HEARING REPORT
VOLUME 1
PRIVATE PLAN MODIFICATION 52
520 GREAT SOUTH ROAD, PAPAURA
520 GSR LIMITED

Reporting on a proposed private plan modification to rezone land from Future Urban Zone to Mixed Housing Urban at 520 Great South Road, Papakura. The reporting officer is recommending, subject to contrary or additional information being received at the hearing, the application be **APPROVED subject to modifications**.

Hearing Report for Proposed Plan Change 52 (Private) 520 Great South Road to the Auckland Unitary Plan (Operative in part)

Figure 1: Proposed Road Layout – Great South Road (indicative)

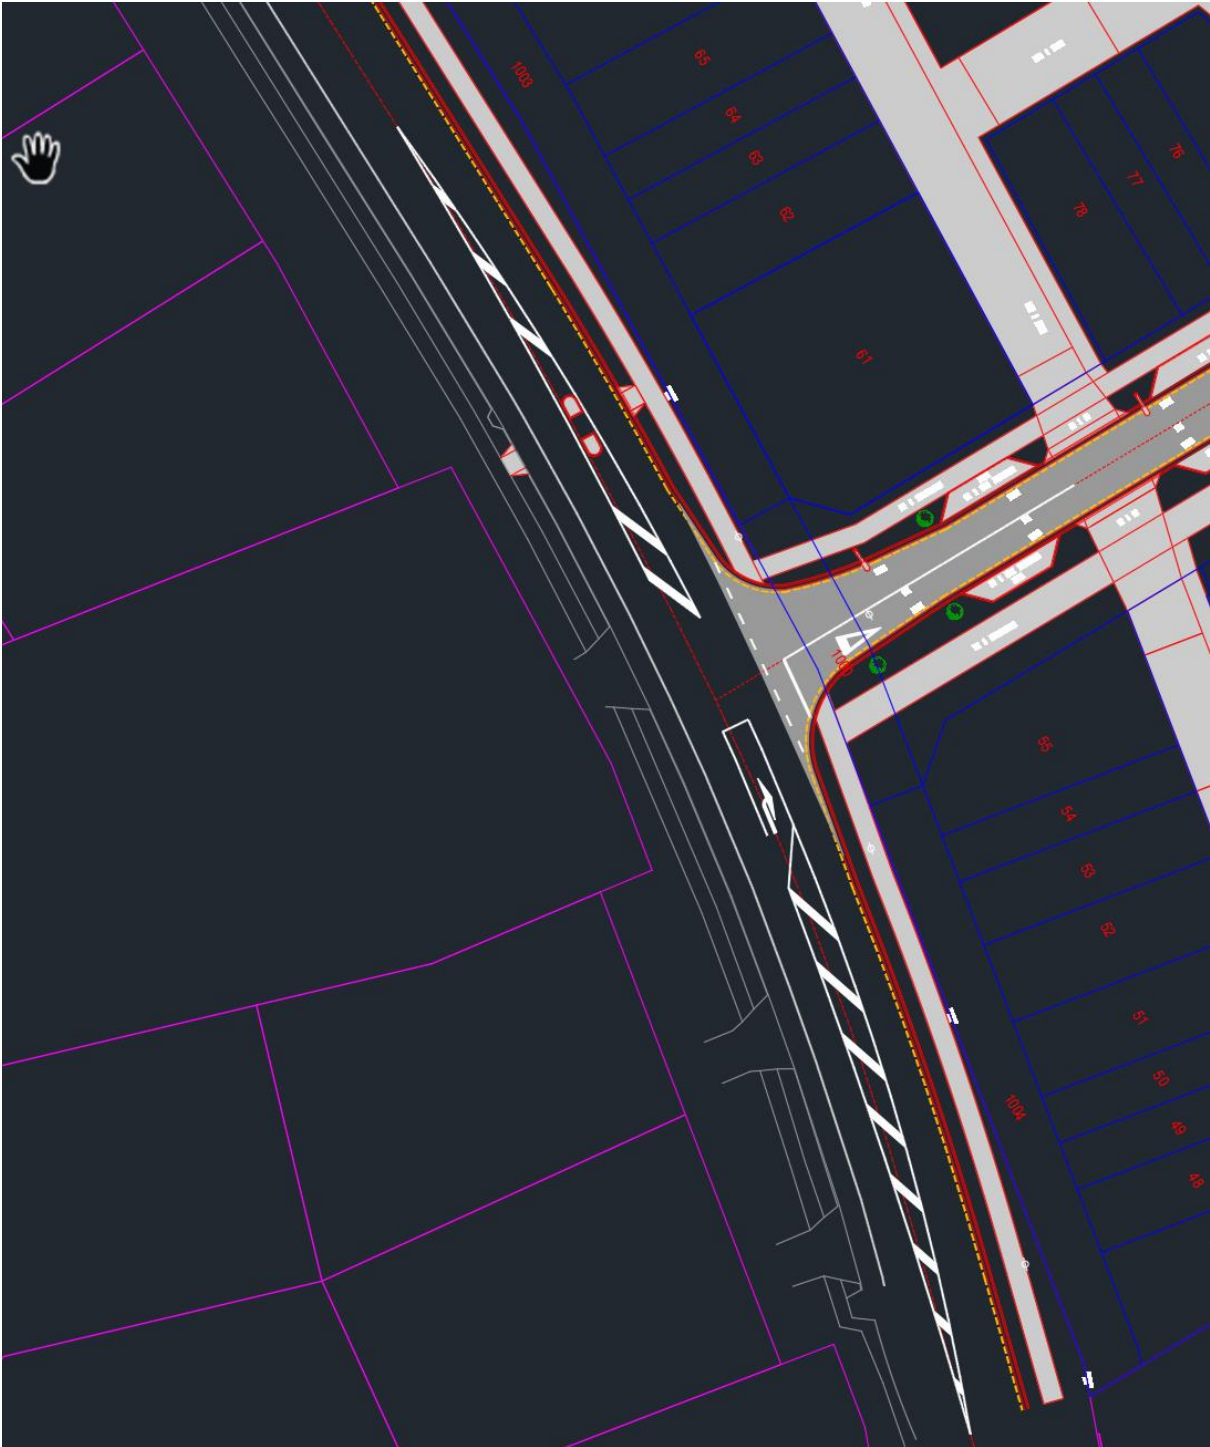
Although not clear in Figure 1. It is anticipated that a portion of the existing private land will be required to accommodate the road widening, right turn pocket and a suitable berm width. The final details of the road widening will be subject to discussions with Auckland Transport at the time of subdivision of 520 Great South Road and the new vested roads within the PPC area. As part of the resource consent application for 520 Great South Road, a 5.0 metre setback is proposed.

Figure 1 also illustrates a setback of 5.0 metres from the existing road boundary to accommodate any future widening of Great South Road. This is consistent with boundary setbacks immediately north of the site.

Figure 3: Great South Road corridor width

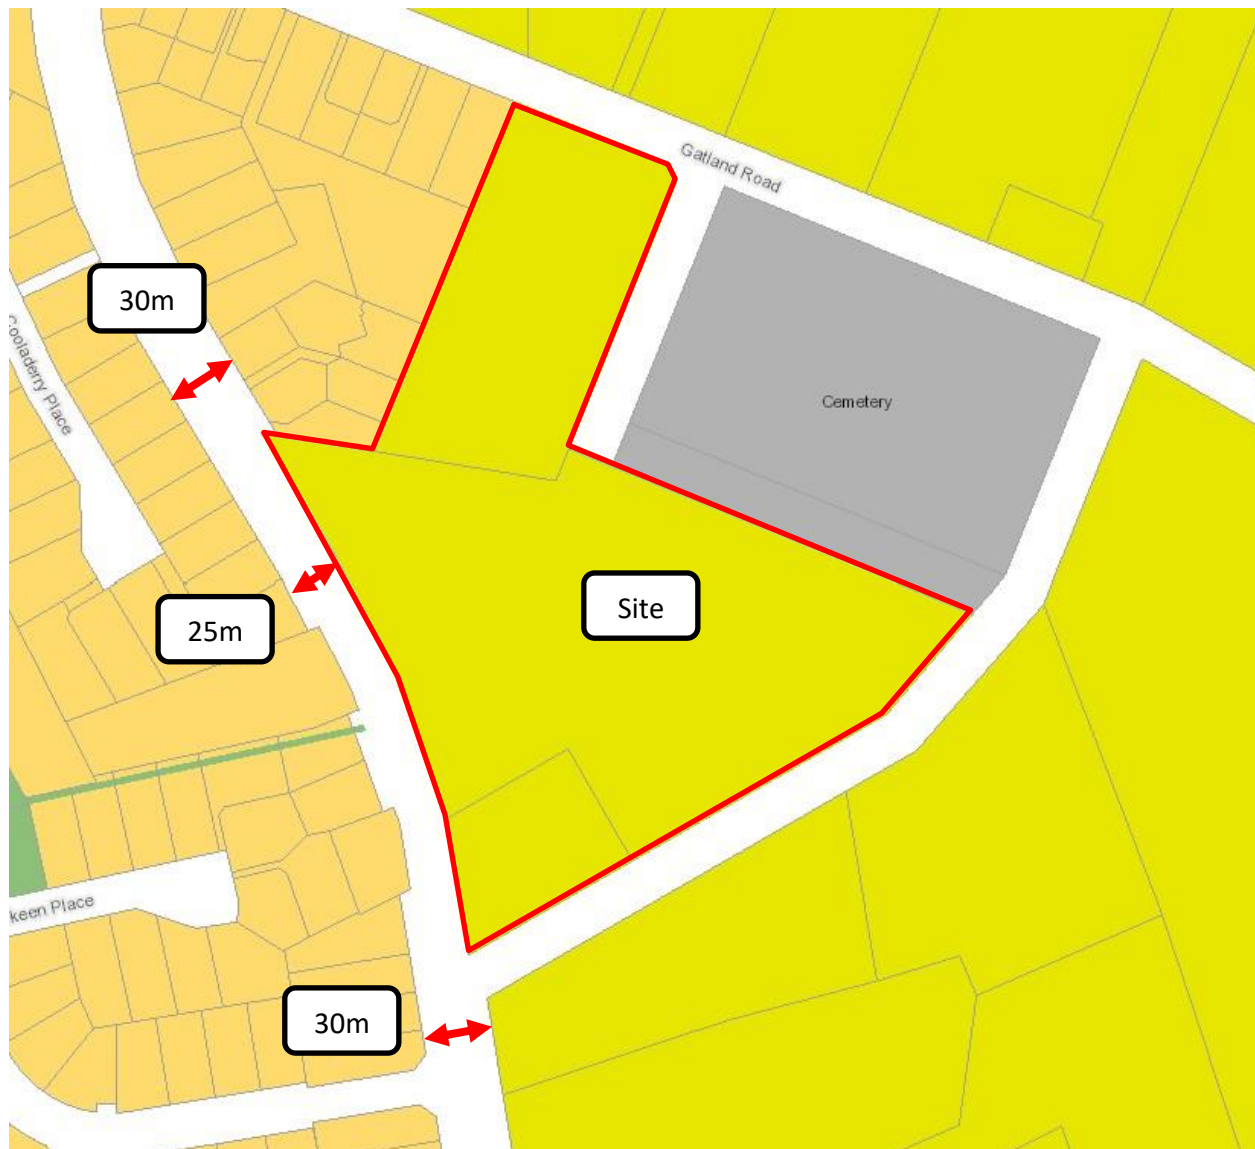
to allow acquisition of this land by Auckland Transport. This would allow a 30 m wide corridor, consistent with the width of Great South Road to the north and south of the site, as shown in Figure 3.

I recommend the applicant vest sufficient frontage on Great South Road and provide a right turn bay and compliant berm along the Site frontage. I recommend that a 5.0m development setback from the existing road boundary is provided to allow future widening of the Great South Road corridor.

Figure 4: Internal street layout for proposed resource consent

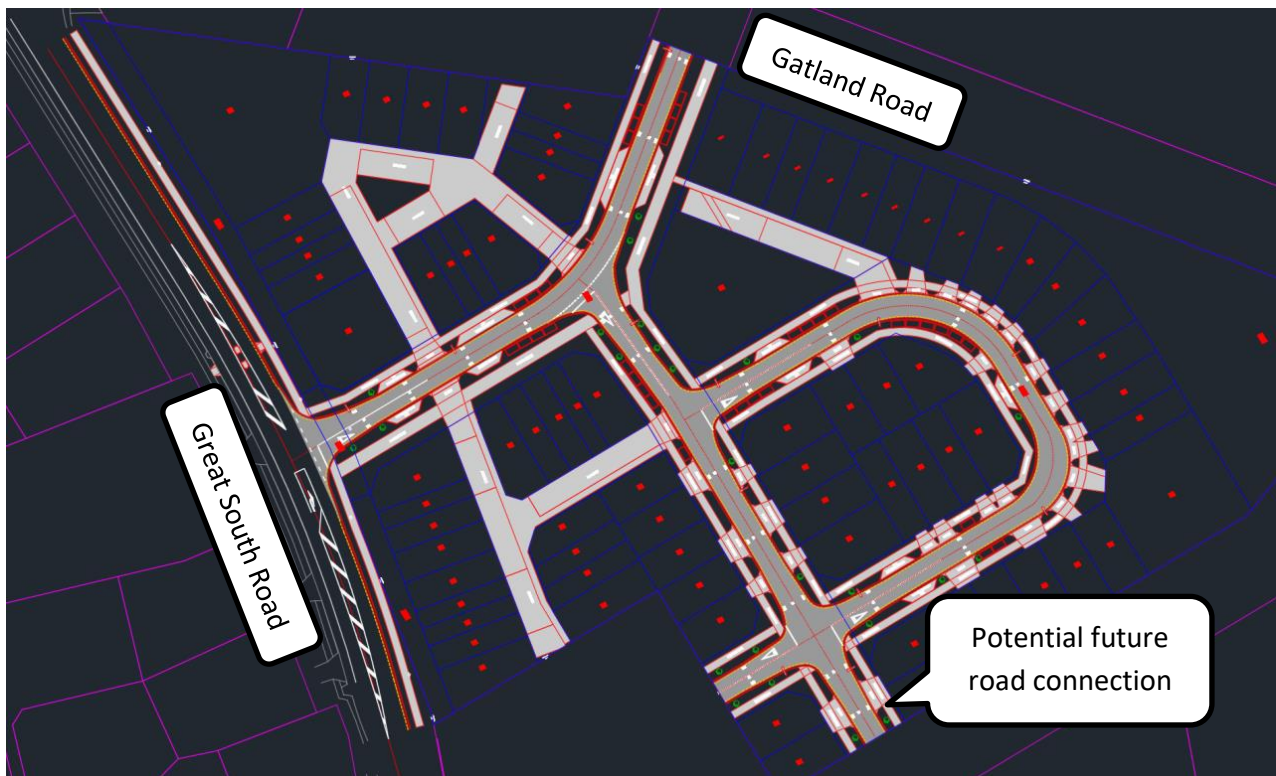
The applicant responded that the proposed subdivision plan included a dead-head street which could be extended to adjacent land parcels in the future, as shown in Figure 4.

I recommend that connectivity to Future Urban Zoned land is provided as part of future subdivision, as shown on the proposed subdivision plan provided by the applicant.

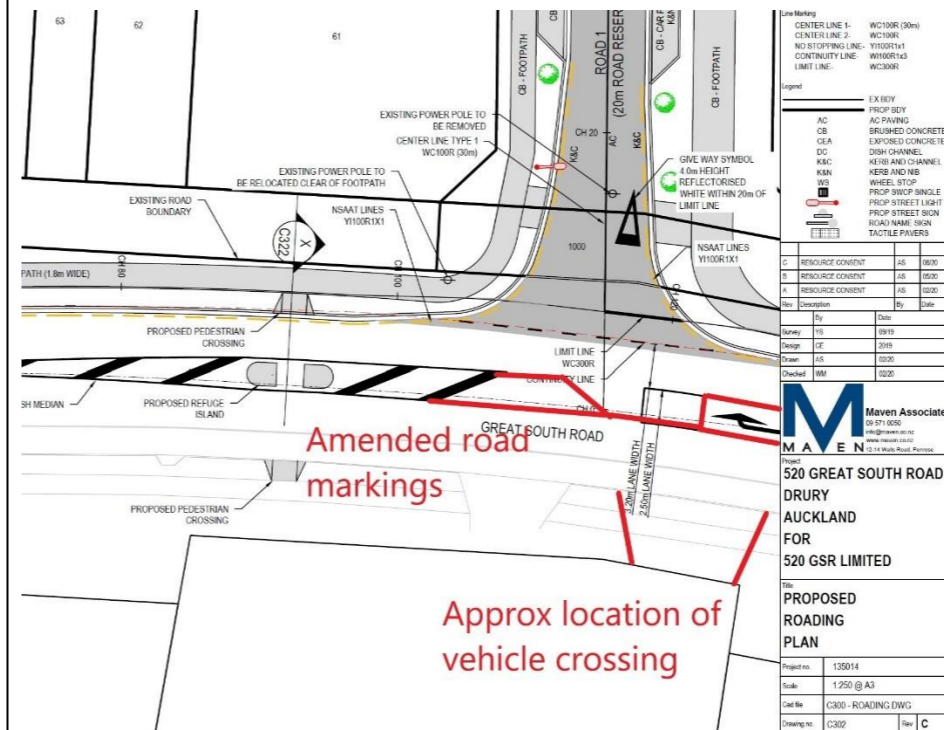
The image below shows amendments to the line markings for the intersection, which has been submitted to Council as part of a separate resource consent parallel to PPC52. Further design work would be needed, but I consider that the limit line for the right turn bay can be set back slightly so it does not block access to 541 Great South Road. This may require the relocation of the Road 1 intersection a few metres to the south.

Alternatively, should a solution in this location not be feasible, the intersection could be relocated somewhat north, where there are no vehicle crossings on the western side of Great South Road.
